**AGENDA**  
**PLANNING COMMISSION PUBLIC HEARING / REGULAR MEETING**  
**FEBRUARY 17, 2022, 7:30 P.M.**  
**CITY OF FARMINGTON HILLS,**  
**CITY HALL – CITY COUNCIL CHAMBERS**  
**31555 W. ELEVEN MILE ROAD, FARMINGTON HILLS MI 48336**  
**Cable TV: Spectrum – Channel 203; AT&T – Channel 99**  
**YouTube Channel: <https://www.youtube.com/user/FHChannel8>**  
**[www.fhgov.com](http://www.fhgov.com)**  
**(248) 871-2540**

**A. SPECIAL APPROVAL 53-1-2022**

LOCATION:	29411 W. Twelve Mile Rd.
PARCEL I.D.:	23-14-226-004
PROPOSAL:	Gasoline station and convenience store in B-1, Local Business District
ACTION REQUESTED:	Special Land Use Approval including Site Plan Approval by Planning Commission
APPLICANT:	Bazco Holdings, LLC
OWNER:	Bazco Holdings, LLC

# Site Plan Review

PROJECT NUMBER  
**21090**  
SHEET NUMBER  
**C-1**

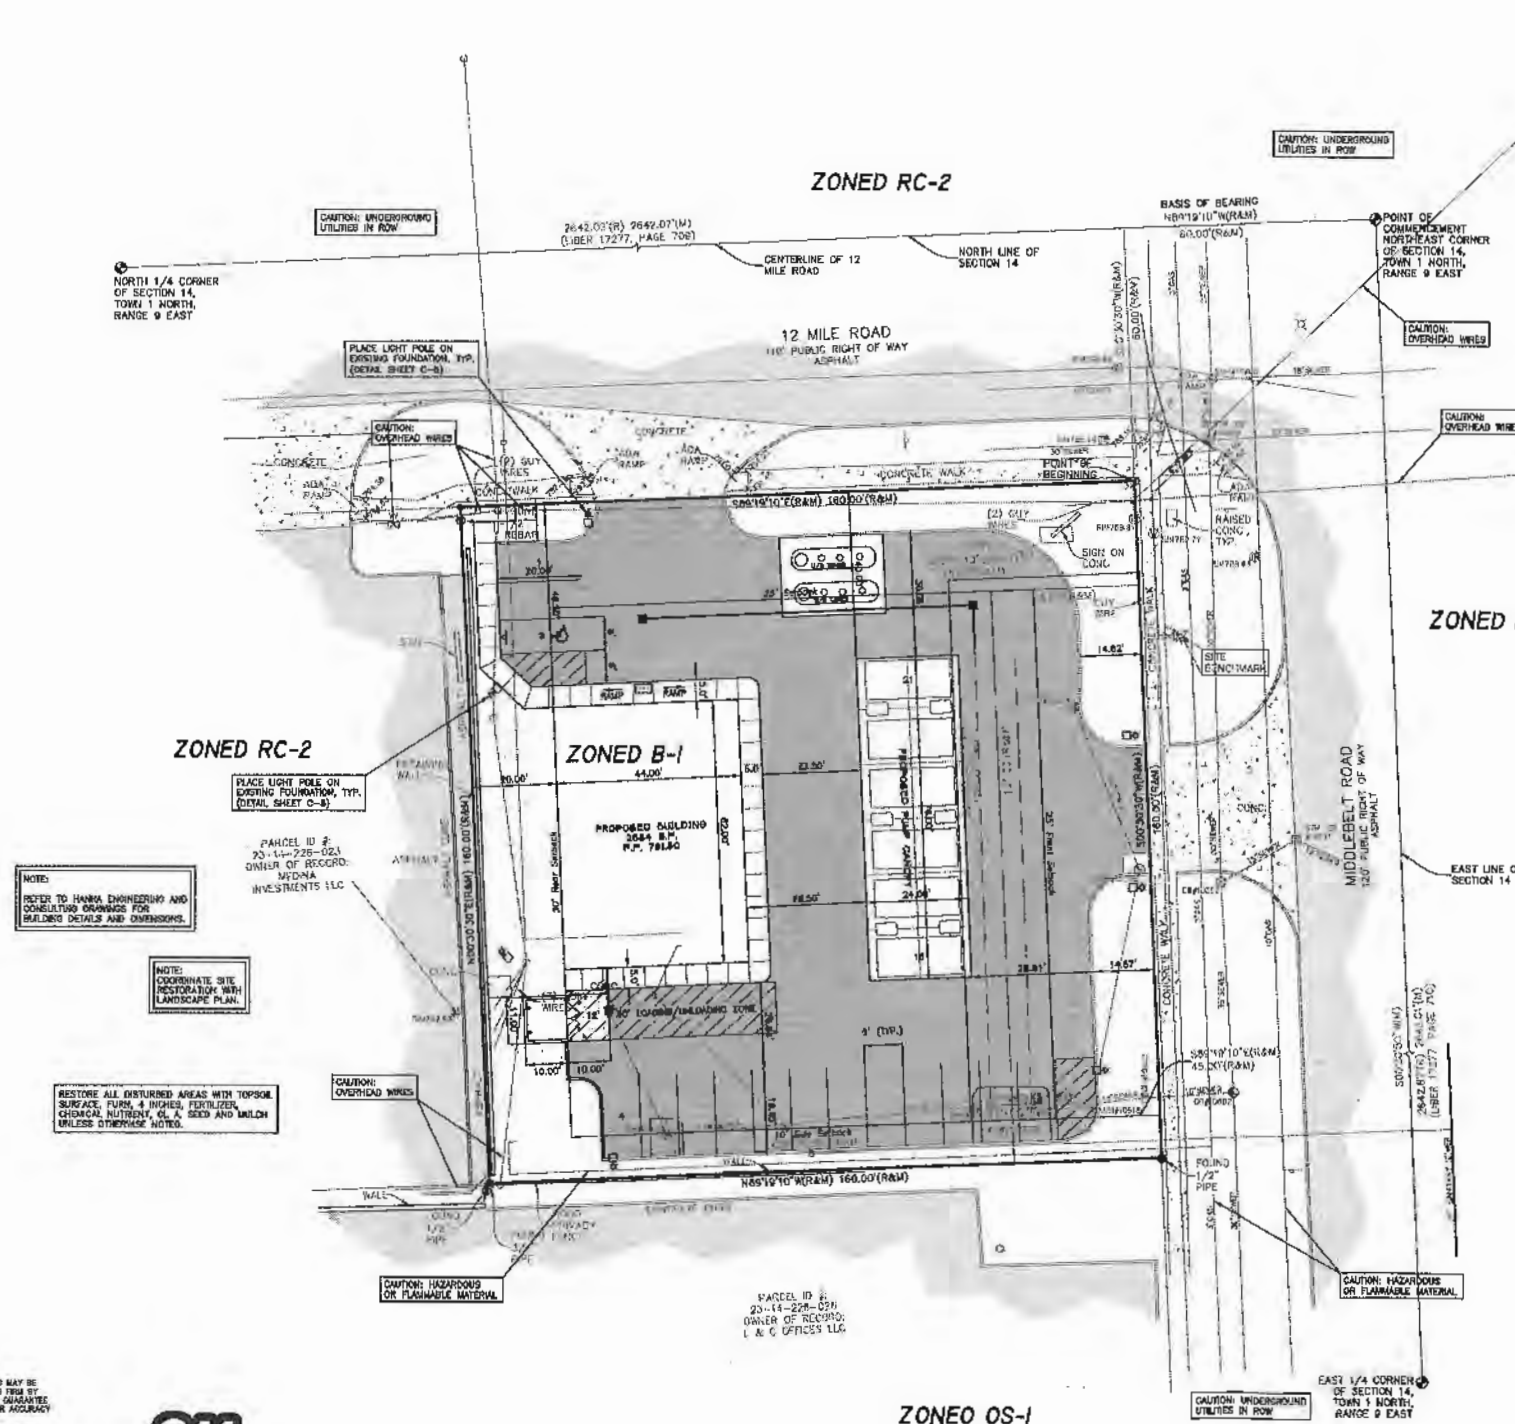
- Inadequate labeling of buffer width on Sheet C-1.
- Address rooftop and other mechanical equipment.
- Address loading area and blocked spaces.
- Calculation of paved area needed to determine tree requirement; status of existing trees.
- Planning Commission to review method of parking lot screening.
- Lighting plan adjustments required.

Landscape area abutting street or freeway (34-3.5.2.V.)	A landscaped area not less than ten (10) feet deep	Varies and appears compliant, but width of each section should be labeled to verify compliance <sup>1)</sup>

- 1) When measured, the landscape buffer depth appears to be adequate; however, this should be dimensioned on the plan.
- 2) This area should be enlarged by 20 square feet. Because this area blocks access to 5 parking spaces, the applicant should be prepared to address how this will affect daily functioning on the site, such as by designating three of these spaces as employee parking or scheduling deliveries outside of busy hours.

PROJECT NUMBER  
21090  
SHEET NUMBER  
C-1A

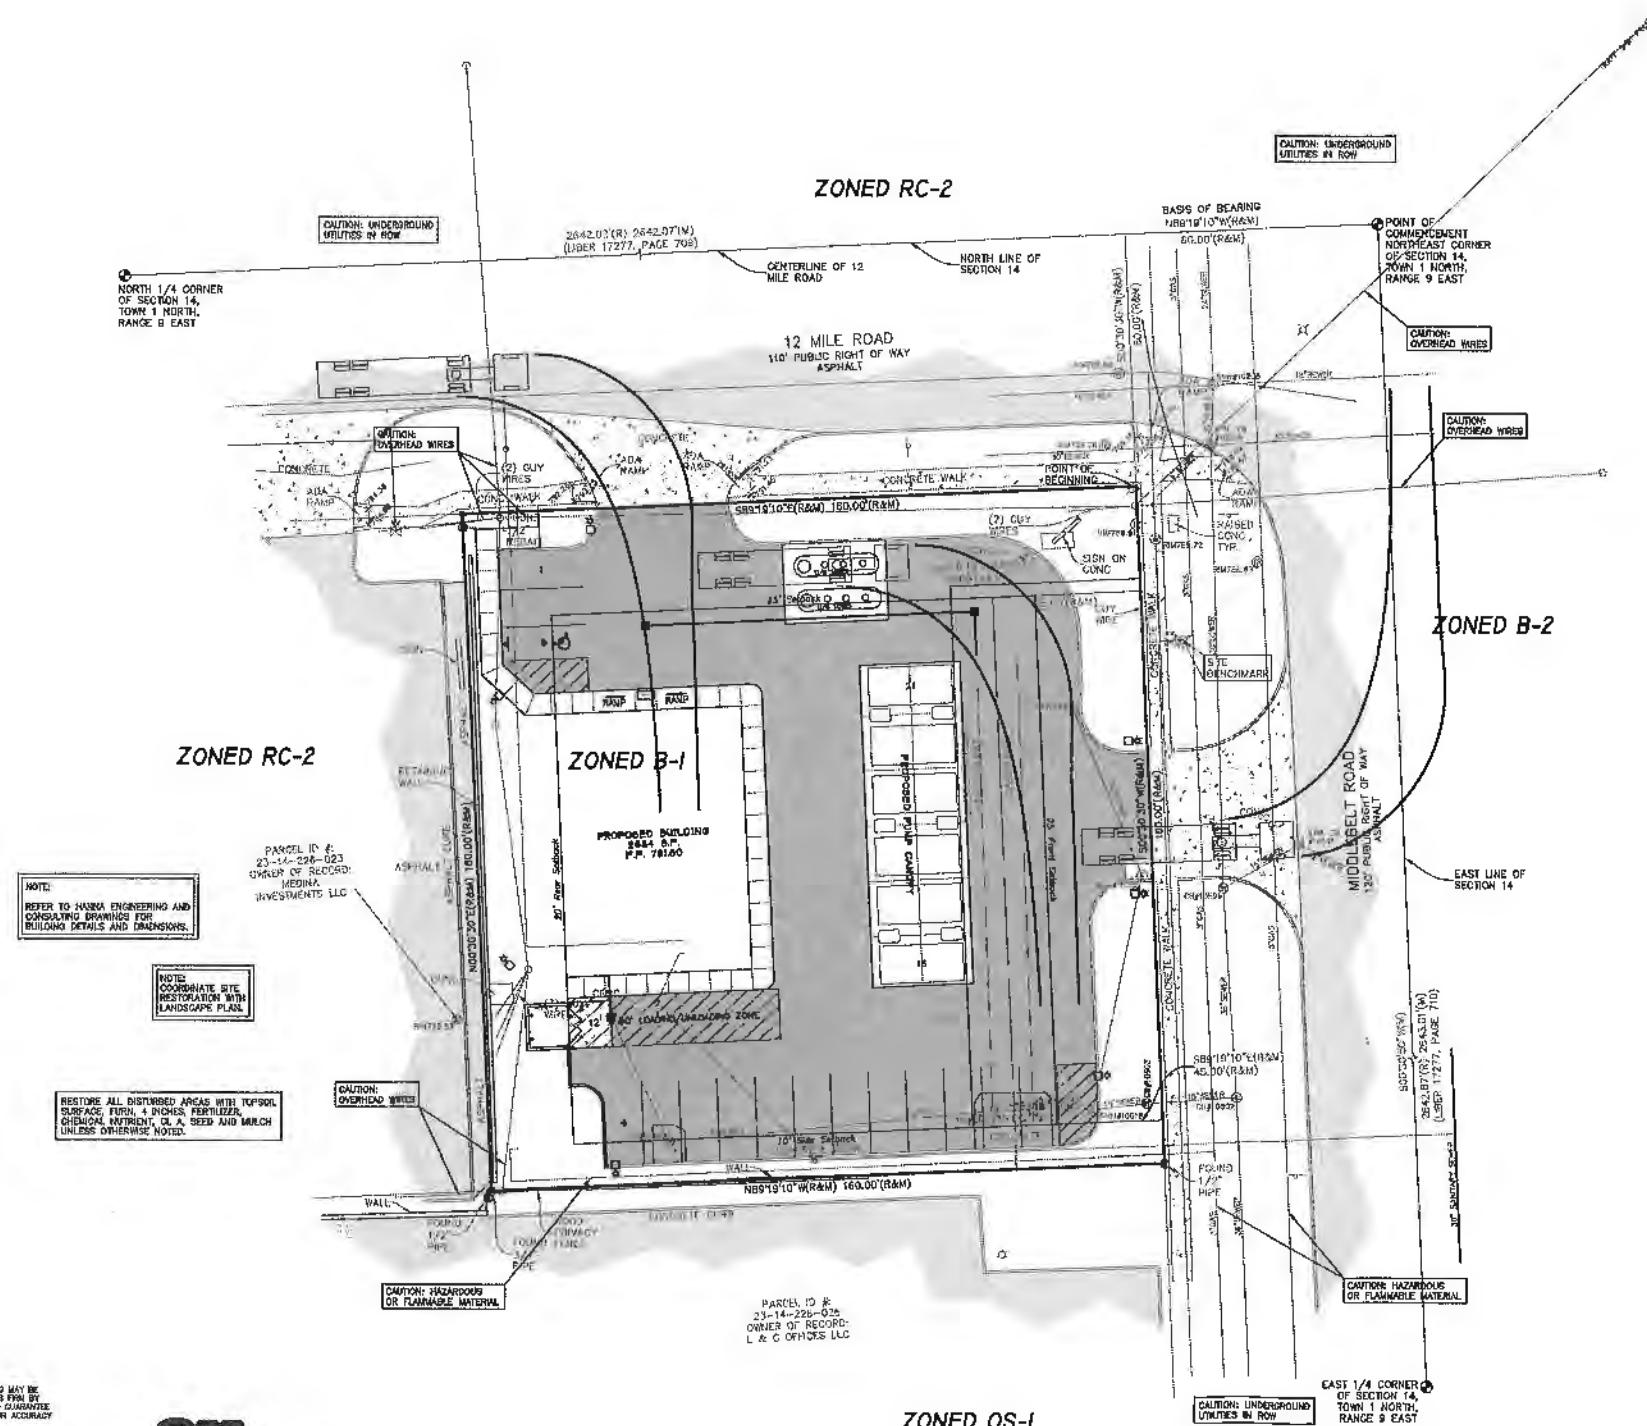
9. **Circulation.** See notes about Sheet C1-A above.

SHEET NUMBER  
L-1

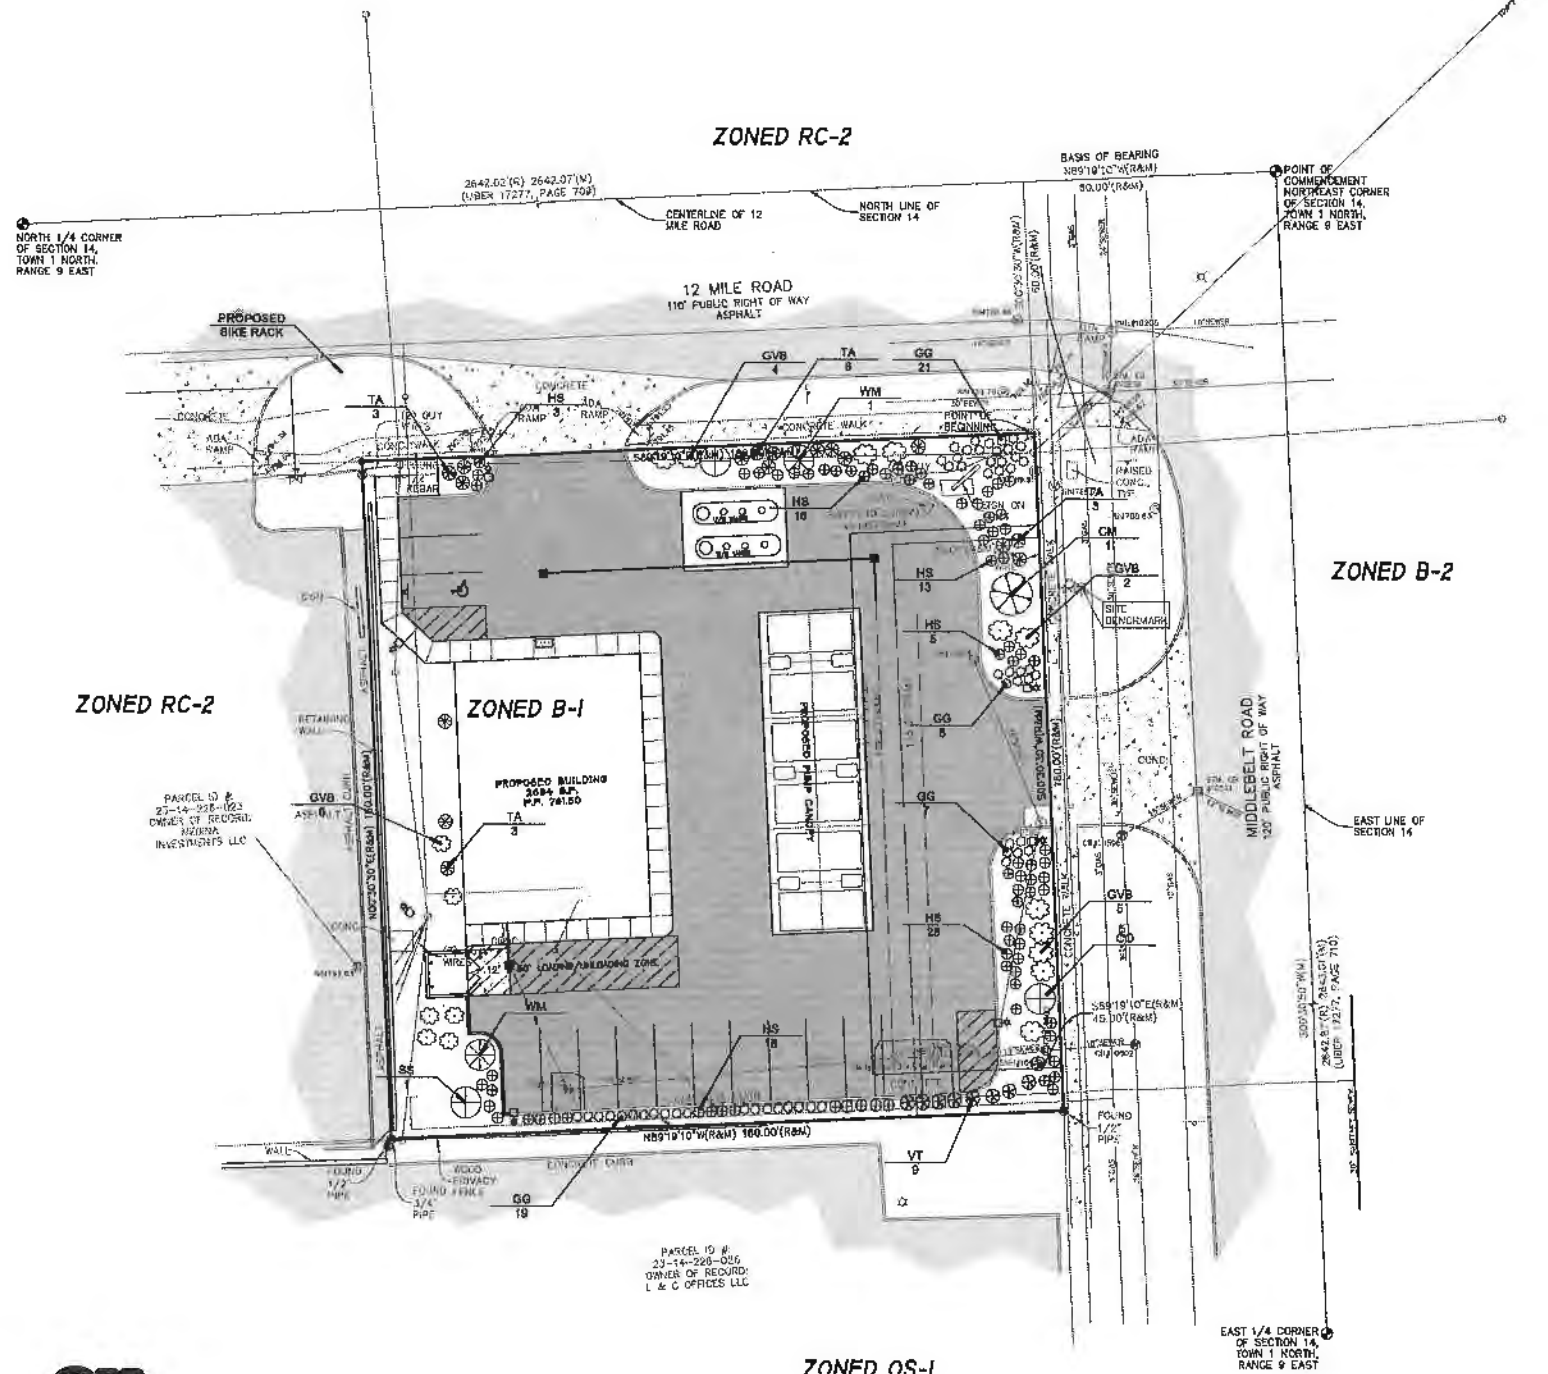
10. **Corner Clearance (34-5.10).** Corner clearance standards appear to be met, but this should be shown on the plan (preferably on Sheet L-1).

• Hedge shrubs	24 in. height	3 ft.	3 ft.	No hedge
Canopy Trees	Shall be large deciduous. PC may permit large evergreens			2 large deciduous trees provided, plus 3 ornamental; <b>there is one unlabeled tree shown on the plans in the northern landscape buffer.</b>
Minimum number of parking lot trees (34-5.14.4.C)	1 per every 2,800 square feet of paved surface area:			<b>Paved surface quantity not provided; requirement unknown</b>
Parking lot screening from public thoroughfare (34-5.14.5)	A planted hedge of small shrubs, or A masonry wall or berm of 2 feet high			No hedge is provided, but the dense shrub arrangements will have a similar effect. <b>Planning Commission to review and comment.</b>
Wall or Berm (34-5.15)	Required when abutting a residential district. (See 34-5.15)			Not required
Tree replacement (34-5.18)	0 required			No existing trees will be removed.

SHEET NUMBER  
C-1

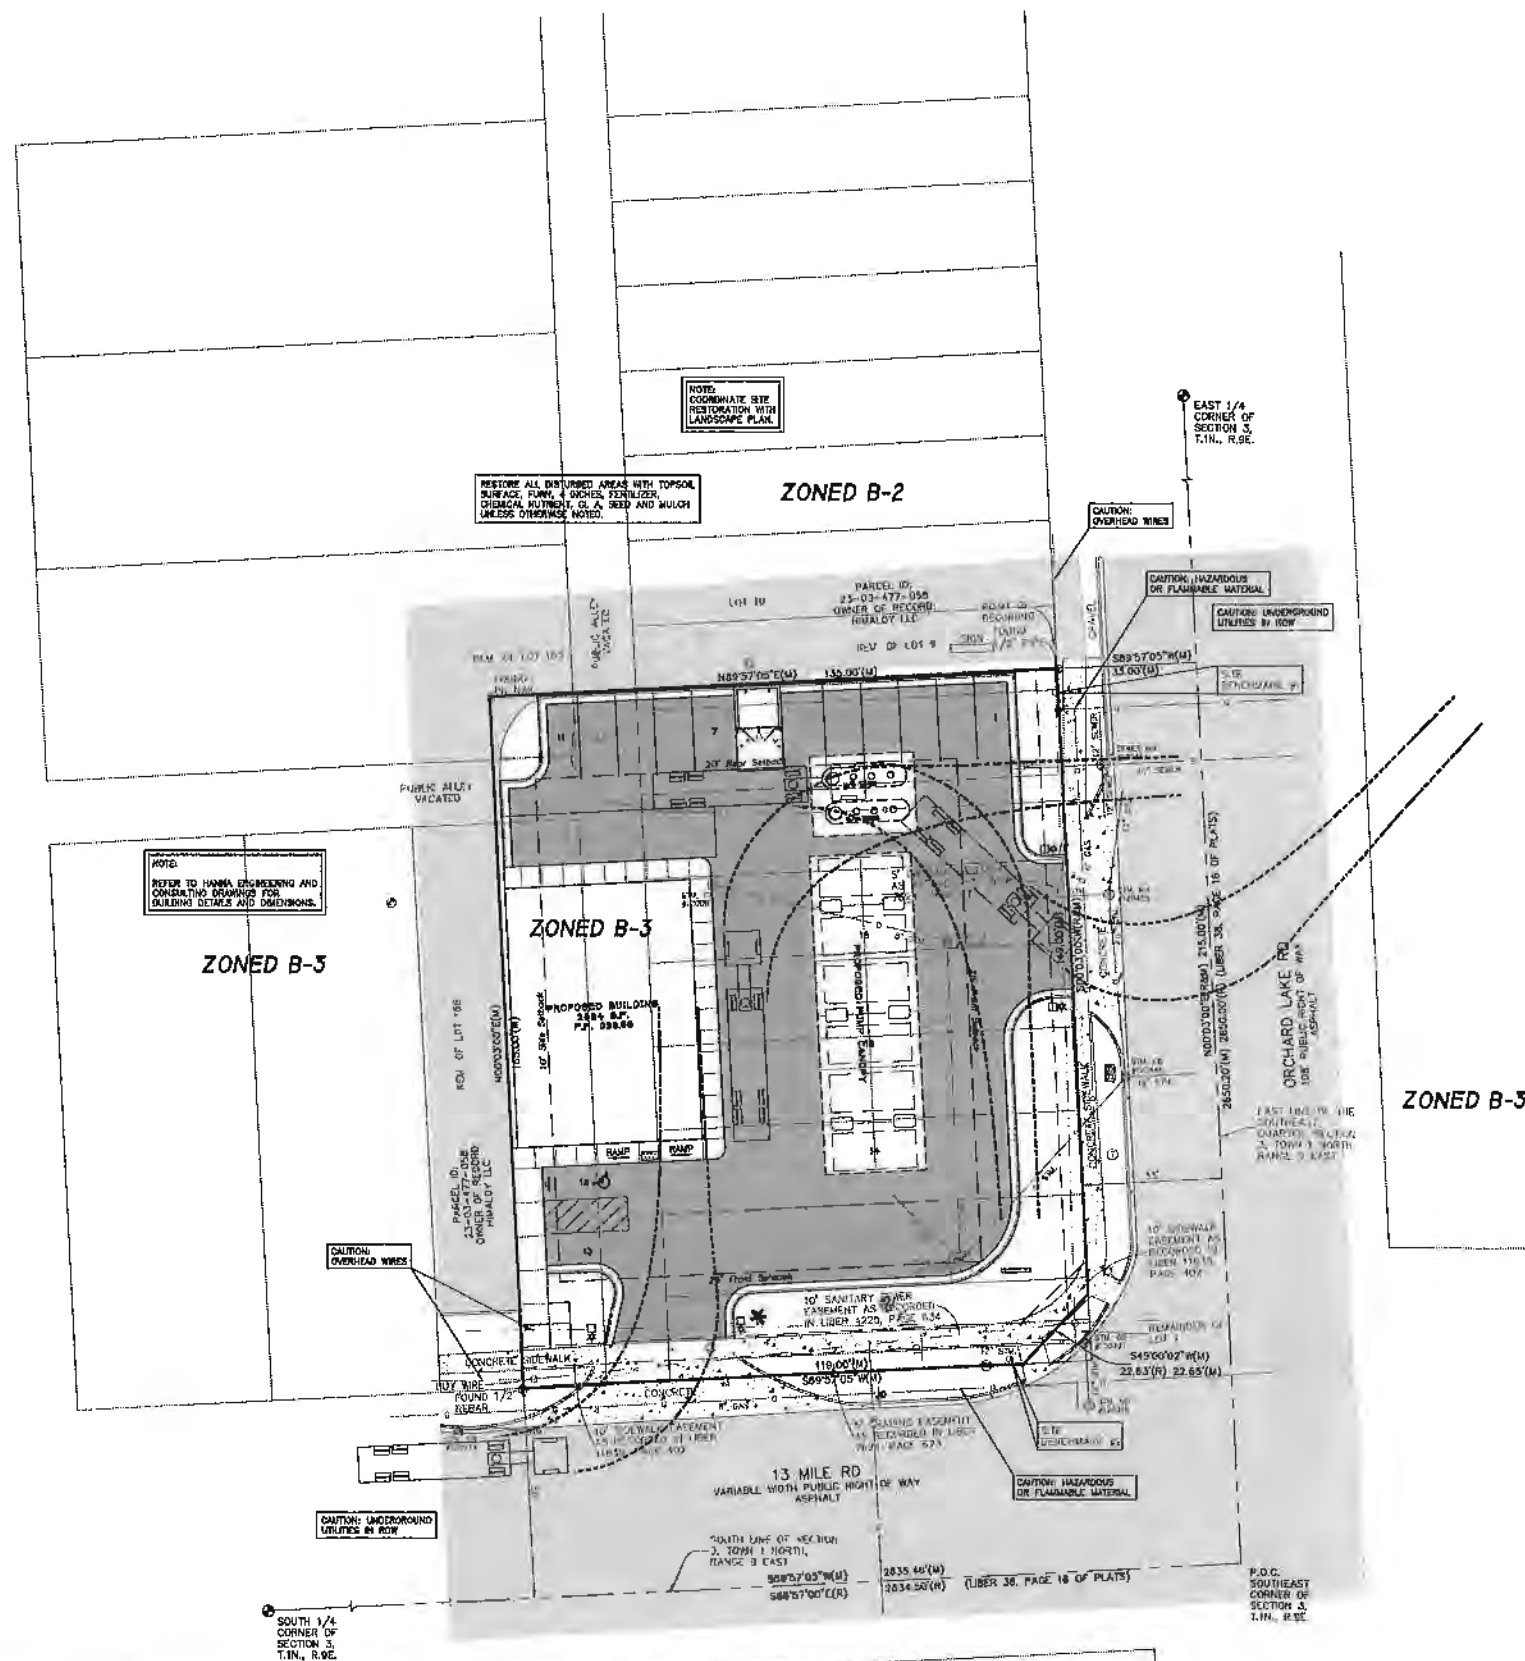
- Variance required for west side setback.
- Inadequate labeling of setbacks and buffer widths on Sheet C-1.
- Address rooftop and other mechanical equipment.
- Address loading requirement/labeling/blocked spaces.
- Calculation of paved area need to determine tree requirement.
- Applicant proposing mixture of shrubs rather than uniform hedgerow for parking lot screening.  
PC to confirm if acceptable.
- Lighting plan adjustments required.
